Name: STOCKYARDS INDUSTRIAL PARK ADDITION

Re: S/D 85-110 - Preliminary Plat of Stockyards Industrial
Park Addition.

Preliminary Plat
SUBDIVISION REPORT

S/D No.: 85-110 Name: STOCKYARDS INDUSTRIAL PARK ADDITION

(PROPOSED)
STOCKYARDS INDUSTRIAL PARK
 WICHITA, SEDGWICK COUNTY, KANSAS

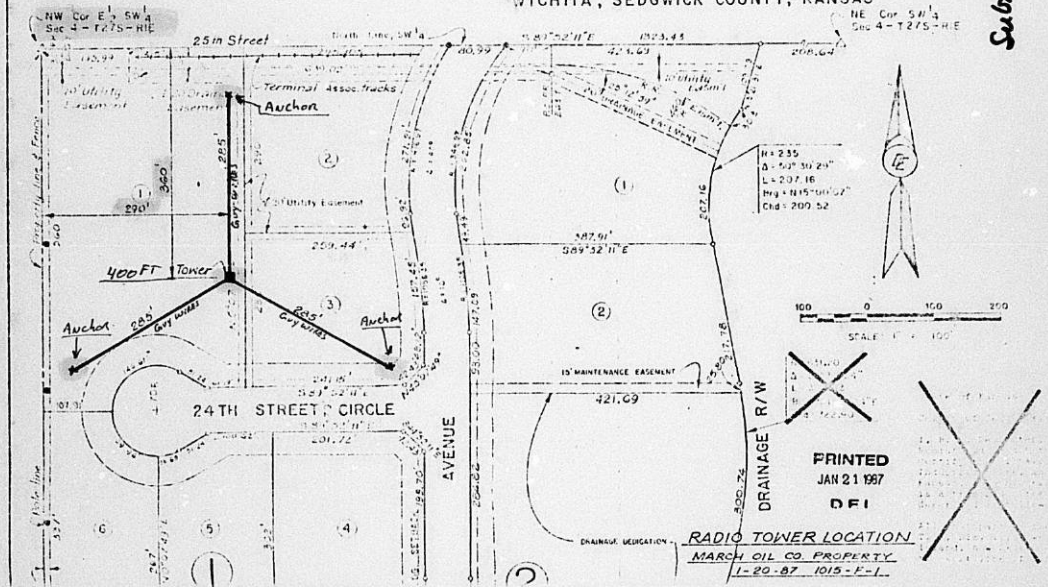
- A. The applicant shall guarantee the extension of sanitary sewer to serve the lots being platted.
- B. The applicant shall guarantee the extension of City Water to serve the lots being platted.

- C. The applicant shall guarantee the paving of the proposed interior streets.
- D. The applicant shall guarantee the storm sewers and storm drain required by the platting of this property.

- E. If improvements are guaranteed by petition, a notarized certificate listing the petitions shall be submitted to the Planning Department for recording.

- F. The final plat shall indicate "access control except for one opening" to 21st Street North across the south lines of Lot 15, Block 1 and Lot 10, Block 2.

- G. The plat's text shall make proper reference to the access controls being dedicated. Regarding the two driveways which exist to 21st Street from Lot 10, Block 2, the plat's text shall state that "said Lot 10, Block 2 shall retain the two existing driveways to 21st Street North until said lot is redeveloped."

- H. The final plat shall label the 35-foot building setback being platted from the adjacent public streets.
- I. The final plat shall indicate the platting of the 35-foot building setback from 21st Street North through the existing building which encroaches into the setback area. Central Inspection has advised that the platting of this building setback does not preclude the property owner from maintaining or remodeling that portion of the building within the setback area. The building cannot, however, be enlarged within the setback and, if the building is removed, any new building construction must observe the platted building setback.

- J. On the final plat, a 20-foot wide contingent street dedication for 21st Street shall be indicated from the south line of Lot 15, Block 1. A 55-foot wide building setback shall be platted from the south line of this lot.

- K. On the final plat, the platlor's text shall reference that the contingent street dedication for 21st Street is dedicated to the public contingent upon the removal of that portion of the existing building which is constructed within the area of the contingent dedication.

- L. The proposed 40-foot wide access easements indicated to serve Lots 1, 2, 3 and 4, Block 2 need to be established by separate instrument with appropriate recording information indicated on the final plat. Prior to recording the joint access easement, a draft shall be submitted to the Planning Department for review and approval. The instrument must clearly state the purpose of the easements as well as which properties benefit from the easements. Initial construction responsibilities and future maintenance of the driveways within the easements should also be addressed by the text of the instrument.

- M. On the final plat, 24th Street and 23rd Street shall be labeled 24th Street Circle and 23rd Street Circle, respectively.
- N. On the final plat, dimensions shall be provided for the 15-foot utility easement on Lot 10, Block 2. If this easement exists by separate instrument, appropriate recording information shall be referenced.

- O. The applicant shall provide proof, by letter from the Continental Oil Company and Bareco Oil Company or by copy of the pipeline easement agreement, that the dedication of street right-of-way over a portion of the pipeline easements is acceptable and that a building setback from the easements is not required. Any relocation, lowering or encasement of the pipeline, caused by development of this property, will not be at the expense of the City.

- P. Prior to scheduling this case before the Board of City Commissioners, the structure(s) which encroaches into the street right-of-way being dedicated by this plat must be removed. Once the structure(s) has been removed, a letter so stating shall be submitted from the platting engineer.
- Q. The applicant shall install or guarantee the installation of all utilities and facilities which are applicable and described in Article 8 of the MAPC Subdivision Regulations.
- R. Requirements for a final plat (see pages 20-25, Part 4, Article 5 of the MAPC Subdivision Regulations).
- S. Prior to, or at the time of submitting the final plat, the applicant shall submit a drainage plan to City Engineering for review and approval.
